## HISTORIC AND DESIGN REVIEW COMMISSION

**HDRC CASE NO:** 2018-155  
**COMMON NAME:** 915 S LAREDO  
**LEGAL DESCRIPTION:** NCB 310 BLK 5 LOT I & E IRR 15.5 FT OF D  
**ZONING:** C-3NA, RIO-7  
**CITY COUNCIL DIST.:** 1  
**APPLICANT:** Judith De Santiago/JD Commercial Realty  
**OWNER:** RGS Holdings, LLC  
**TYPE OF WORK:** New construction of a two story, commercial structure  
**APPLICATION RECEIVED:** March 29, 2018  
**60-DAY REVIEW:** May 28, 2018  
**REQUEST:**

The applicant is requesting conceptual approval to construct a two story commercial structure with surface parking at the corner of S Lareda Street and Guadalupe Street, in RIO-7.

## SITE DIMENSION CONTROL PLAN

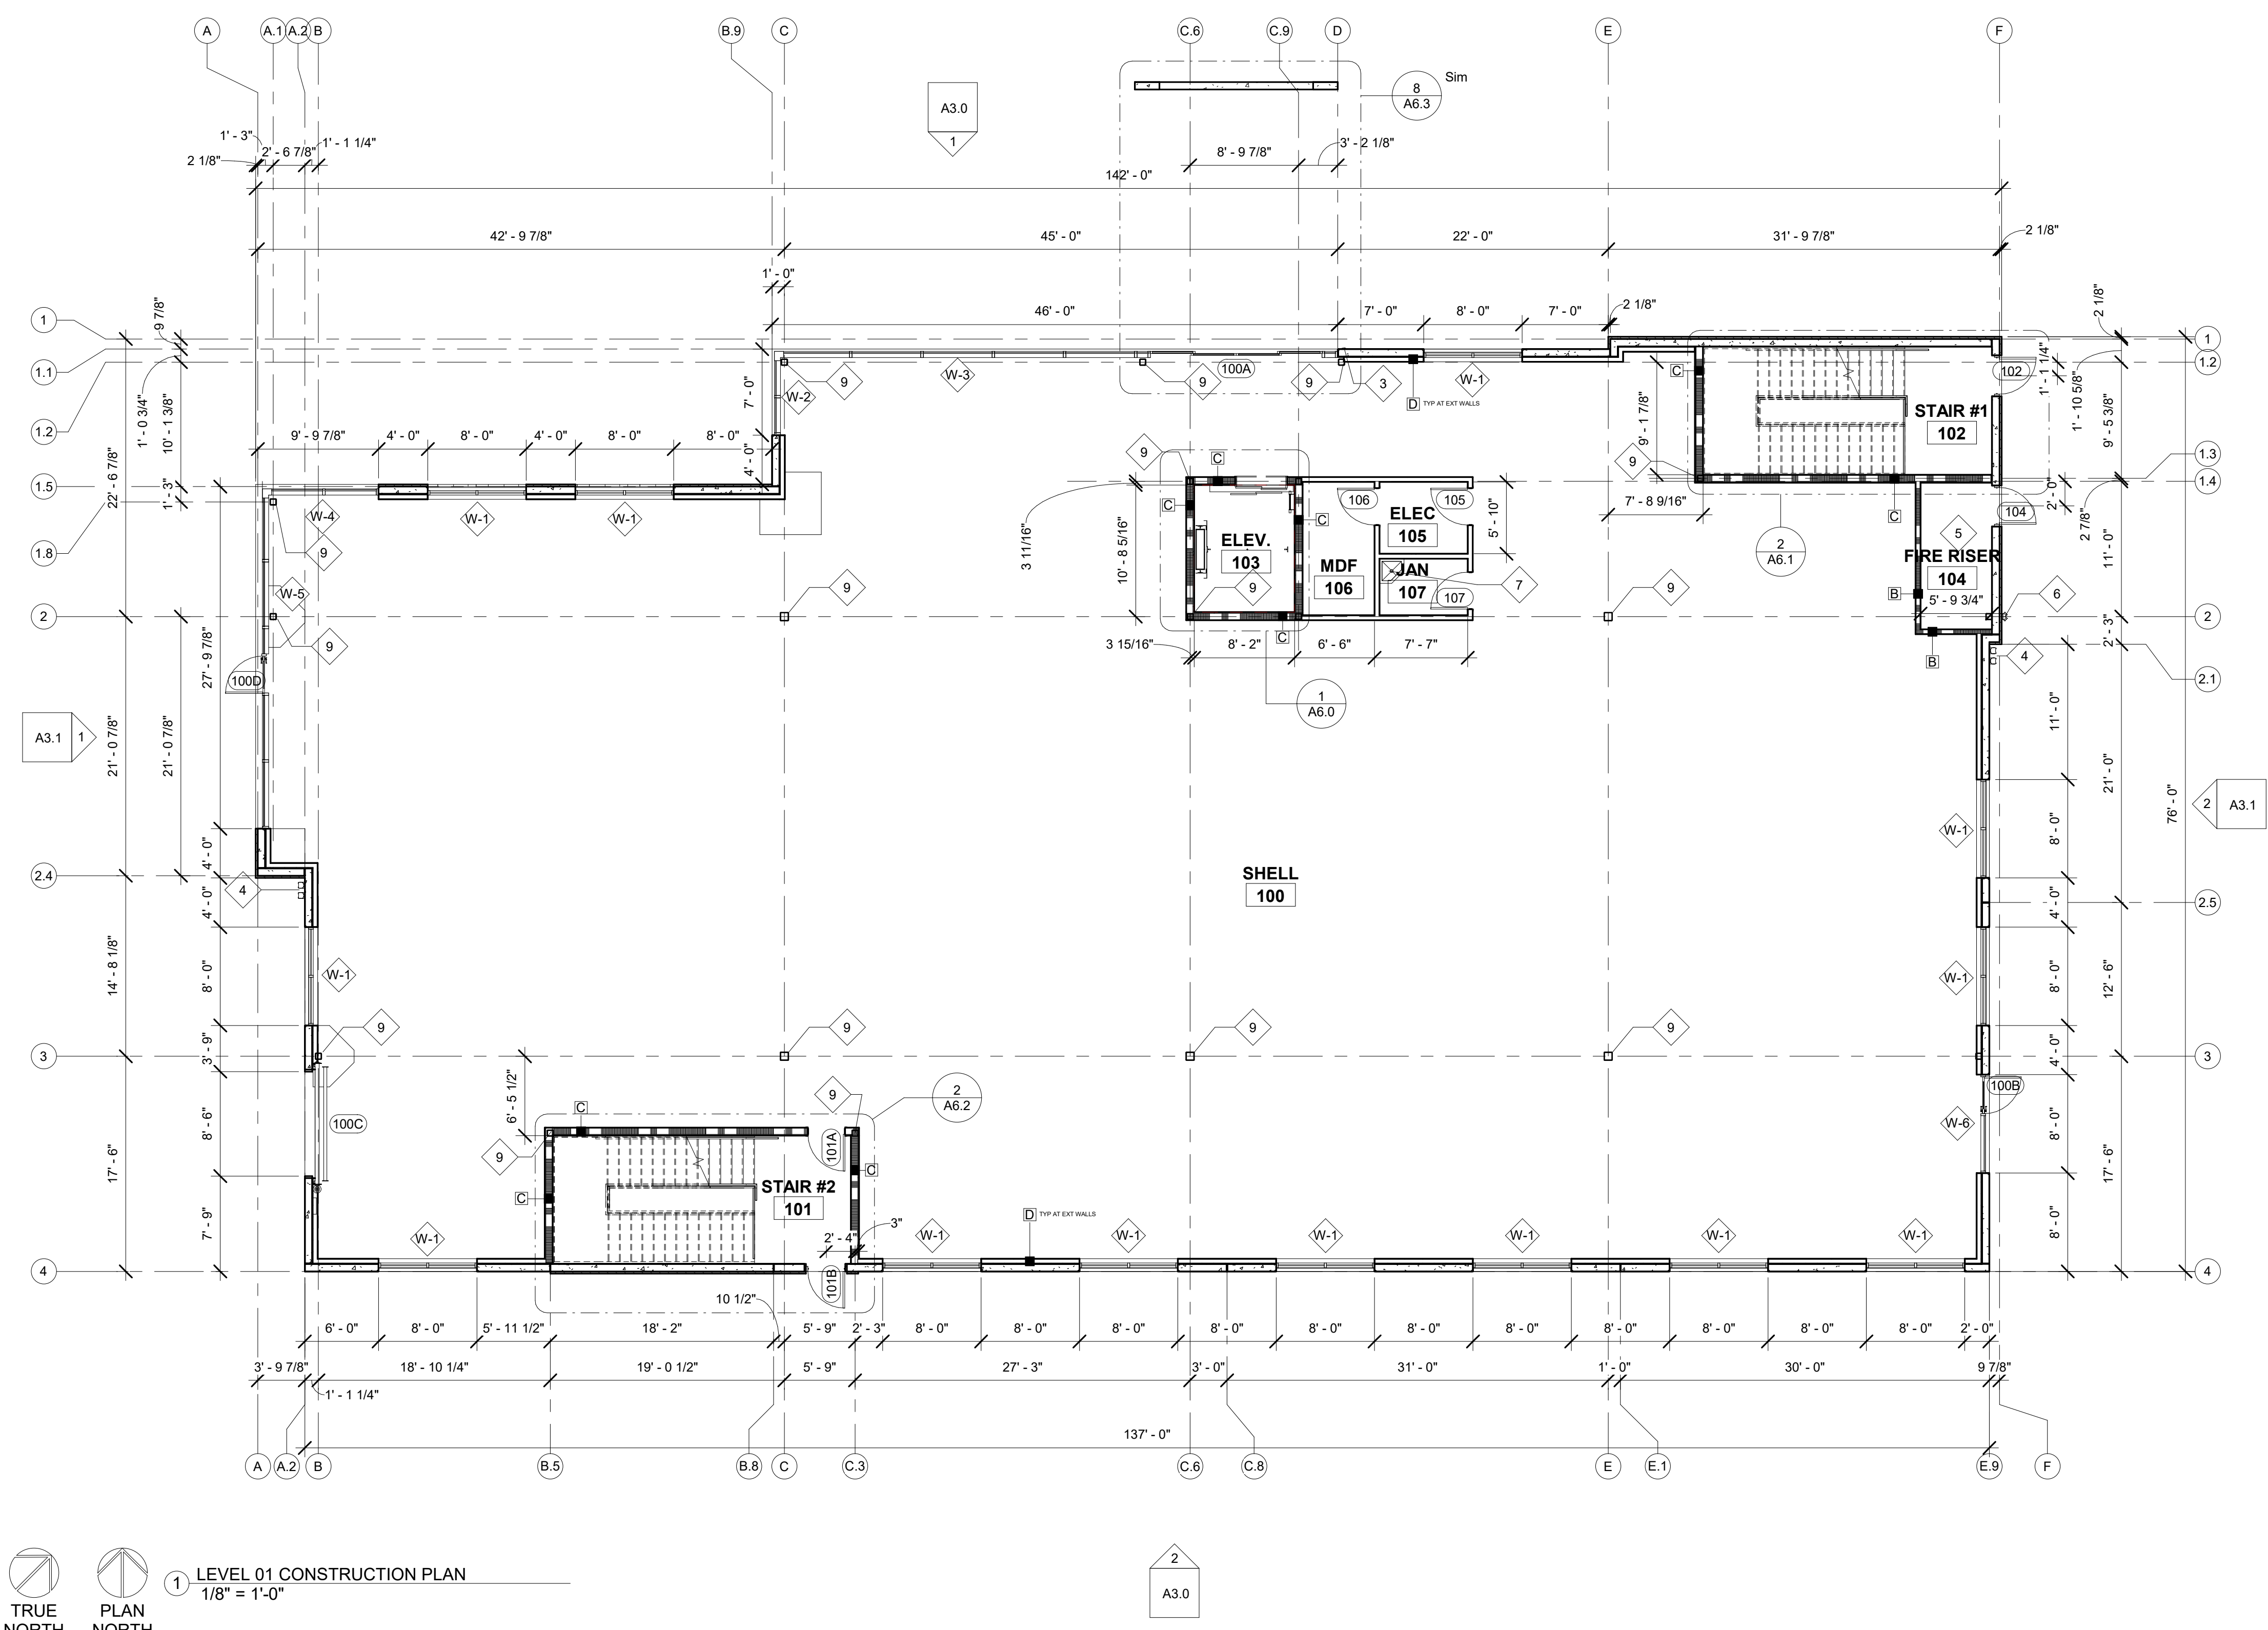
- c. **PEDESTRIAN CIRCULATION** – Per the UDC Section 35-672(a) in regards to pedestrian circulation, an applicant shall provide pedestrian access among properties to integrate neighborhoods. Per the application, the applicant has proposed pedestrian walkways adjacent to the public right of way at S Laredo and Guadalupe and around the proposed new construction. This is consistent with the UDC.

- f. **SITE DESIGN** – According to the UDC Section 35-673, buildings should be sited to help define active spaces for area users, provide pedestrian connections between sites, help animate the street scene and define street edges. Primary entrances should be oriented toward the street and shall be distinguishable by an architectural feature. The applicant has located primary entrances on the south and west facades, interior to the site and away from the primary street. This is inconsistent with the UDC.

- i. That automobile parking be buffered from the public right of way at the sidewalk along S Laredo as noted in finding e.
- ii. That the proposed primary entrances be shifted to the S Laredo and Guadalupe facades or that entrances of appropriate design and hierarchy be introduced on these facades as noted in findings f and l.
